August 31, 2018

Project No. 30401358

**RE: MONTHLY STATUS UPDATE – SOIL CAP AND CONCRETE CAP REPAIRS
UNION PACIFIC RAILROAD HOUSTON WOOD PRESERVING WORKS FACILITY
4910 LIBERTY ROAD FACILITY, HOUSTON, TEXAS
POST-CLOSURE CARE PERMIT NO. HW-50343; INDUSTRIAL SWR NO. 31547**

FIGURE
2

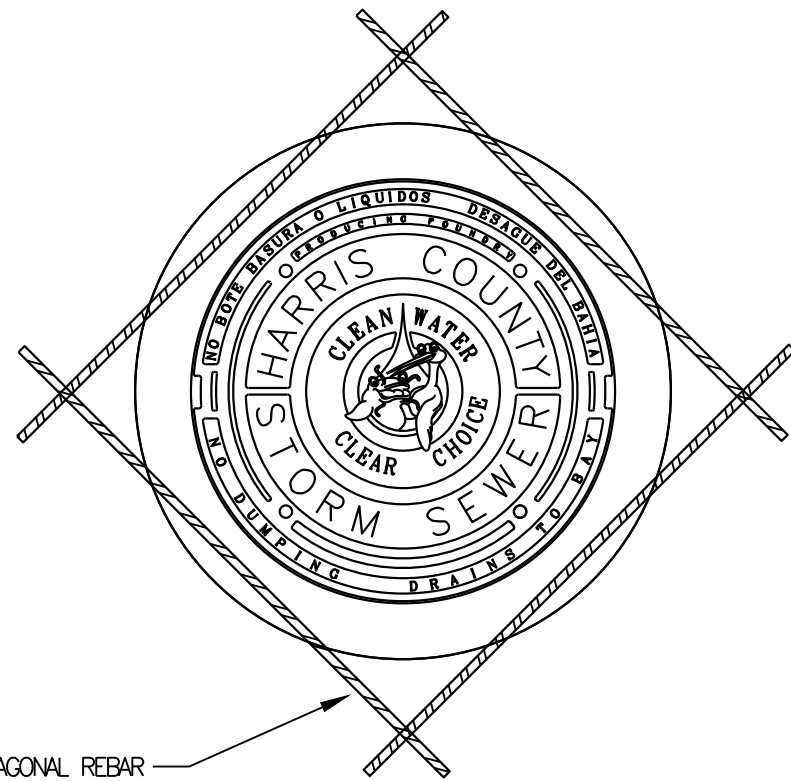
- *Please provide details on the revised response action design to address future subsurfacing of the tar-like substance.*

Response: Golder developed a response action design to address the tar-like substance seeps present in the B100 to B109 parking slots. The preliminary design drawings are provided in Attachment B of this letter. The preliminary design consists of the following:

- Saw cut and remove the asphalt or concrete cover (approximately 1,395 square feet of area);
- Excavate the existing road base, soil and debris to a depth of approximately 5 feet below grade. The estimated volume of material to be removed is approximately 215 cubic yards (in-place). The excavated material will be placed in roll-off boxes, profiled for disposal, and disposed at a permitted landfill facility;

- Place a geotextile fabric at the base of the excavation, overlain with approximately 3 feet of high permeability fill (i.e., gravel) to allow the collection of non-aqueous phase liquid (NAPL) in the NAPL collection zone;

- Install a vertical 24-in diameter (or similar) HDPE plastic pipe to a depth of 5 feet below grade, with slotted pipe/perforations in the lower 3 feet of the pipe to allow the recovery of NAPL that may collect in the NAPL collection zone; and

- Backfill the remaining 24 inches of the excavation with a combination of compacted select fill, compacted base material, and reinforced concrete to return the ground surface for parking of the container trailers.
